Project	<b>IEEE 802.16 Broadband Wireless Access Working Group</b> < <a href="http://ieee802.org/16">http://ieee802.org/16</a> >	
Title	<b>Proposal to Adopt Relay Frame Structure Option 1</b>	
Date Submitted	<b>2008-10-31</b>	
Source(s)	Jerry Sydir, Alexander Maltsev, Hongang Li, Alexei Davydov Intel Corporation Rakesh Taori, Youngbin Chang Samsung Electronics Shashikant Maheshwari, Adrian Boariu, Yousuf Saifullah Nokia Siemens Networks I-Kang Fu, Pei-Kai Liao, Paul Cheng Media-Tek Inc. Fang-Ching (Frank) Ren, Richard Li ITRI	<a href="mailto:jerry.sydir@intel.com">jerry.sydir@intel.com</a>  <a href="mailto:rakesh.taori@samsung.com">rakesh.taori@samsung.com</a>  <a href="mailto:shashi.maheshwari@nsn.com">shashi.maheshwari@nsn.com</a>  <a href="mailto:ik.fu@mediatek.com">ik.fu@mediatek.com</a>  <a href="mailto:frank_ren@itri.org.tw">frank_ren@itri.org.tw</a> <a href="mailto:richard929@itri.org.tw">richard929@itri.org.tw</a>  * <a href="http://standards.ieee.org/faqs/affiliationFAQ.html">http://standards.ieee.org/faqs/affiliationFAQ.html</a> >

# Proposal to Adopt Relay Frame Structure Option 1

Figure 23 Relay Frame structure ~~option 1~~

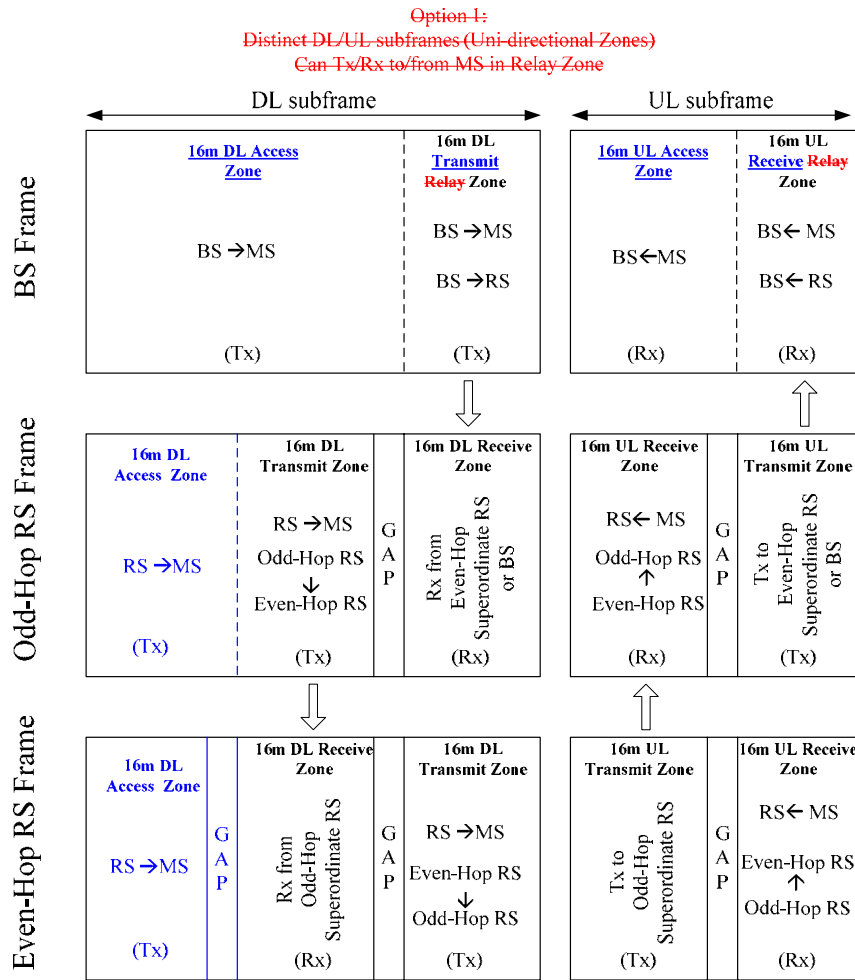
~~There are two options for the Relay frame structure. These are captured in Figure 23 and Figure 24. Further study is required to distill a single frame structure from among these two options. The Relay frame structure is illustrated in Figure 23.~~

*[Modify figure 25 on page 48 as indicated below]*

[Modify the caption of figure 25 on page 48 as indicated below]
